UNITED STATES PATENT AND TRADEMARK OFFICE

APPLICATION NO.	FILING DATE	FIRST NAMED INVENTOR	ATTORNEY DOCKET NO.	CONFIRMATION NO.
10/051,327	01/22/2002	Mary L. Bussler	0981/1	2715

Office Action Summary	Application No. 10/051,327	Applicant(s) BUSSLER, MARY L.	
	Examiner Ted Kavanaugh	Art Unit 3728

DETAILED ACTION

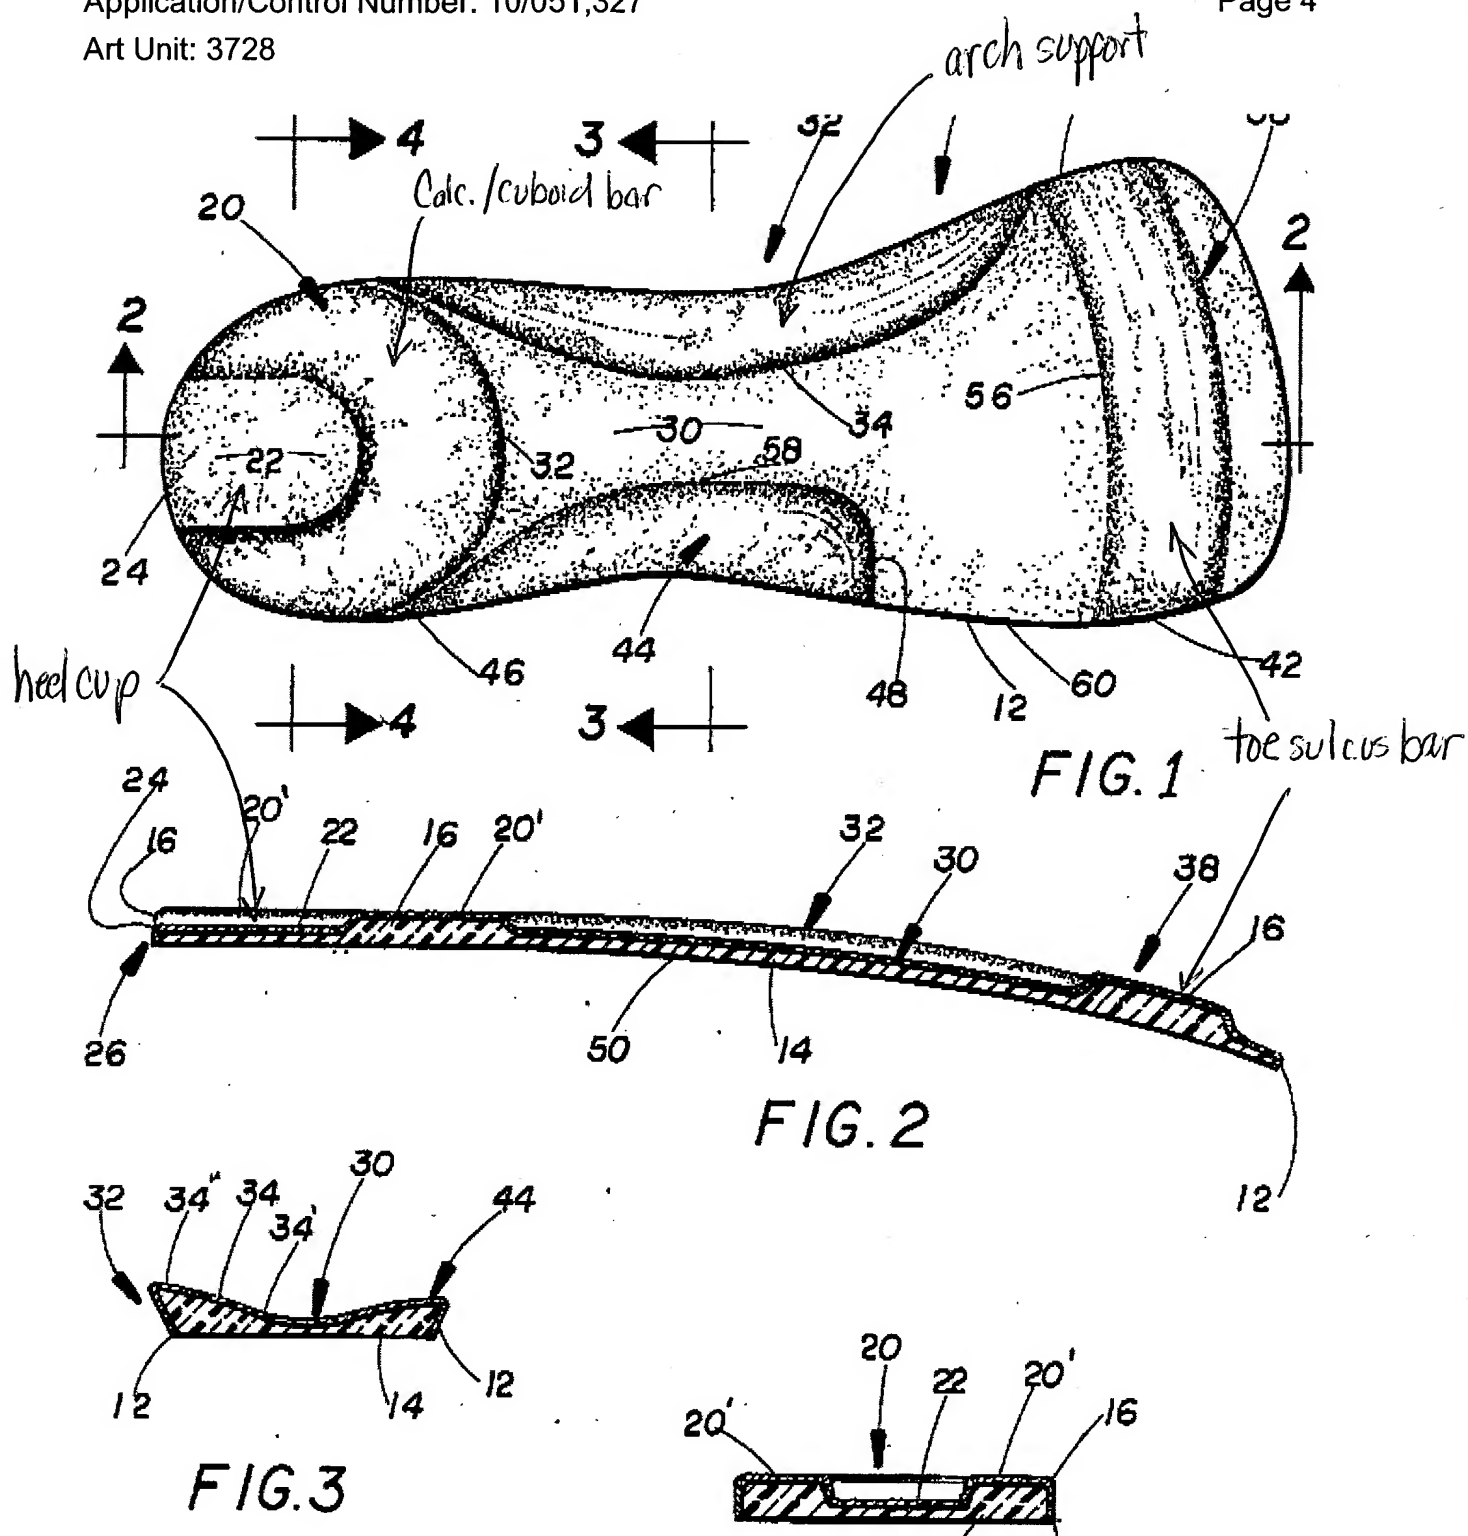
6. Claims 1 and 6-9 are rejected under 35 U.S.C. 102(b) as anticipated by or, in the alternative, under 35 U.S.C. 103(a) as obvious over US 4955148 (Padilla).

Padilla teaches the combination of a high-heeled shoe (see col. 1, lines 12-25) and a footbed (foot support assembly) as claimed, see the marked-up figures below. The foot support provides proper fitting within a give shoe style, see col. 2, lines 5+.
